SECTION 4.55(1A) APPLICATION TO AMEND SSD 10376 | 125 BATHURST STREET SYDNEY

This letter has been prepared by Urbis on behalf of Pitt Street Developer South Pty Limited (the applicant) in support of a Section 4.55(1A) application to modify SSD 10376 which applies to the Pitt Street South Over Station Development (OSD) at 125 Bathurst Street, Sydney.

Figure 2 Pitt Street South OSD proposed building envelope

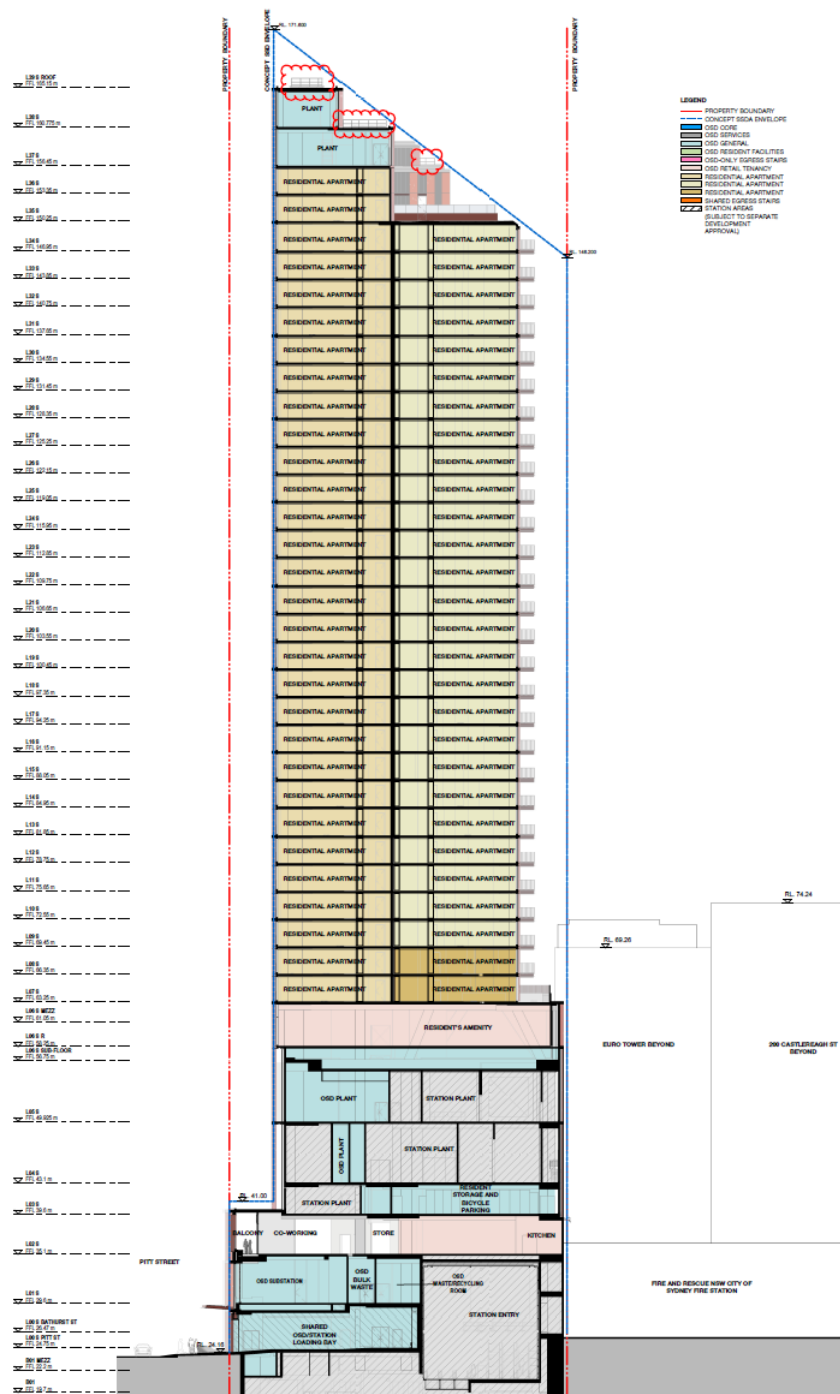
The maximum building height permitted by condition B11 requires minor uplift from RL165.35 to reach an overall height of **RL166.35** to allow for the building envelope to include:

- Two hot water generator flues protruding 600mm above RL165.35
- Six air terminals protruding 800mm above RL165.35
- Top of handrail protruding 1m above RL165.35

The Architectural Plan illustrating the proposed components of the building that will exceed RL 165.35 within this amendment is illustrated in

Figure 2 and found at **Attachment A** where red clouding highlights the protrusion of roof fixtures and other changes to the proposed plans outlined below.

*B11. The maximum height of the approved building must not exceed RL 165.35 m AHD, including plant and lift overruns. **Communication devices, antennas, satellite dishes, masts, flagpoles, chimneys, flues, balustrades** and the like **may extend to a maximum height of RL 166.35**. Details confirming compliance with this condition must be submitted to the Certifying Authority prior to the issue of the relevant Construction Certificate.*

Figure 3 Louvre location on western elevation (blue line indicates approved building envelope)

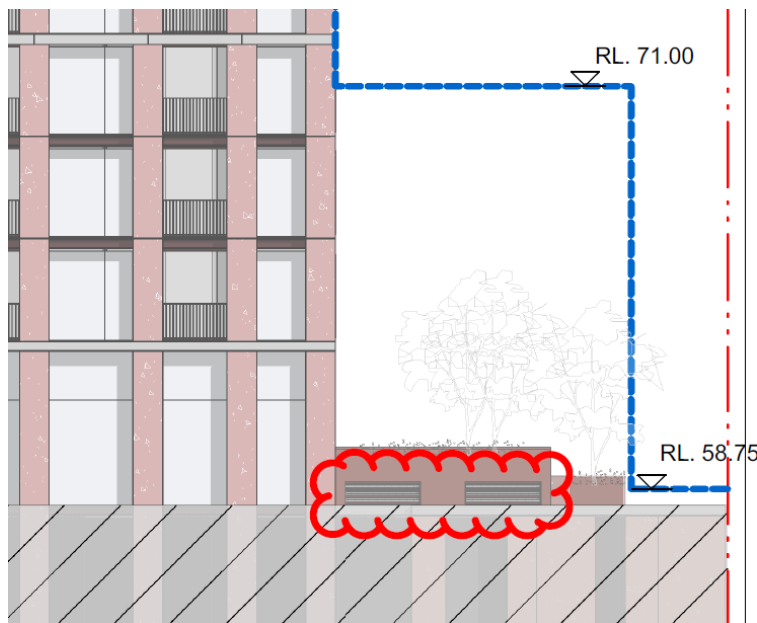
- Revise the approved plans to delete louvres on the southern façade at level 06 and relocate louvres to the western façade of the plant at level 06.

Updates provided in the Architectural Plan reflect the revised louvre location illustrated in **Figure 3**. This is a minor change to the window façade and is necessary due to the stair pressurisation intake being relocated.

Figure 4 Adaptable Apartment updates Levels 11-13

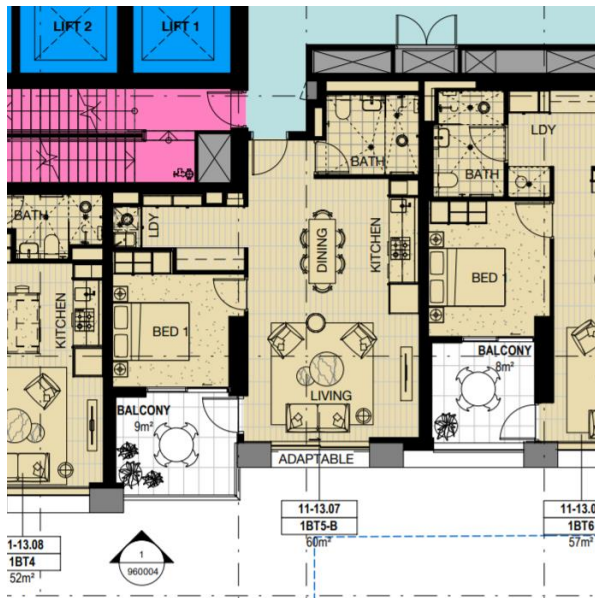
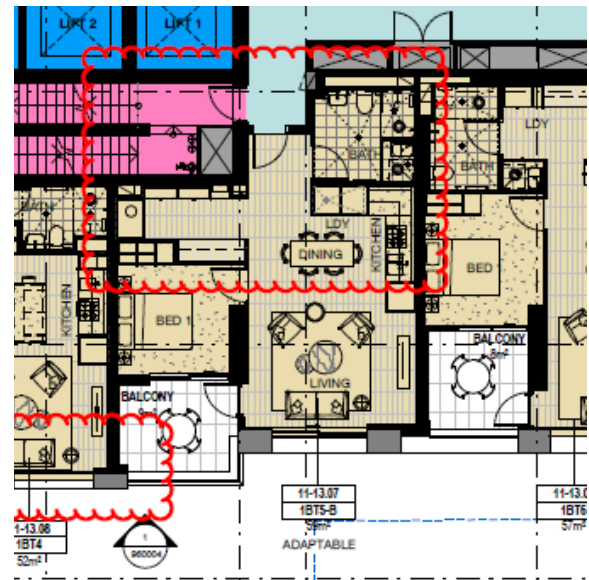
- Levels 11-13 have altered the bathroom configuration to allow greater space for accessibility and moveability through the doorway and bathroom and more clearly labelled 'adaptable one bed apartment'. This is shown through red clouding in **Figure 4**, extracted from the updated Architectural Plans.

Figure 5 Adaptable Apartment updates Levels 33-34

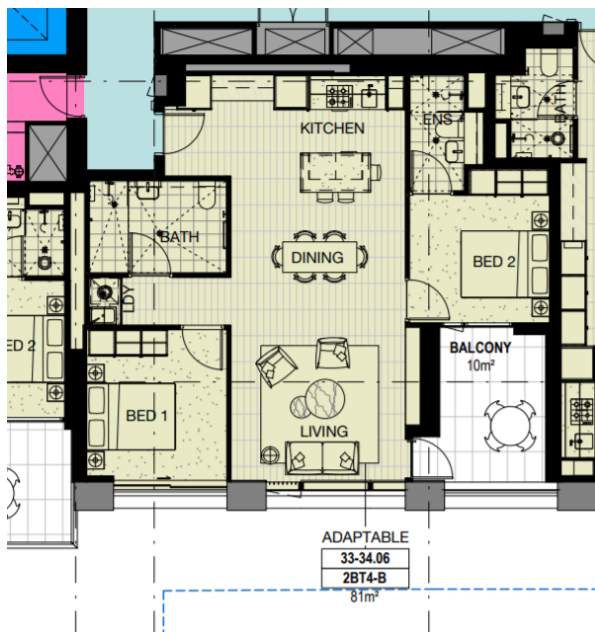
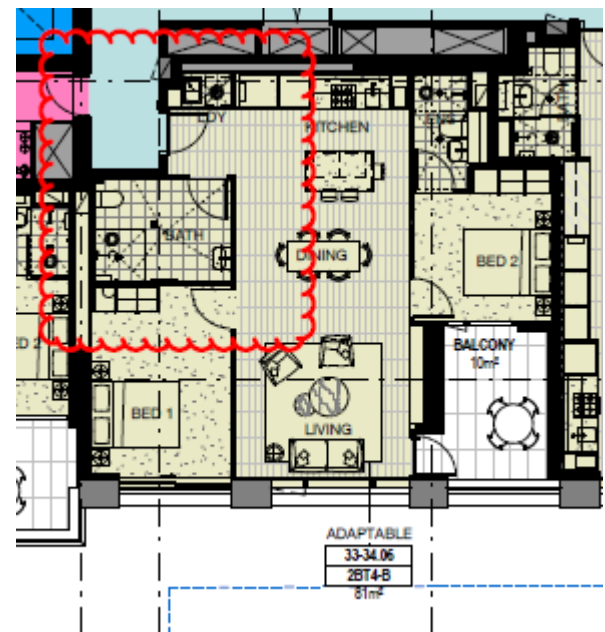
- Level 33-34 plans have re-located the laundry location to allow for greater space within the bathroom and doorway, enhancing accessibility and moveability. Also, providing clearer labelling of 'adaptable two bed apartment'. This is clouded red in **Figure 4** extracted from the updated Architectural Plans.
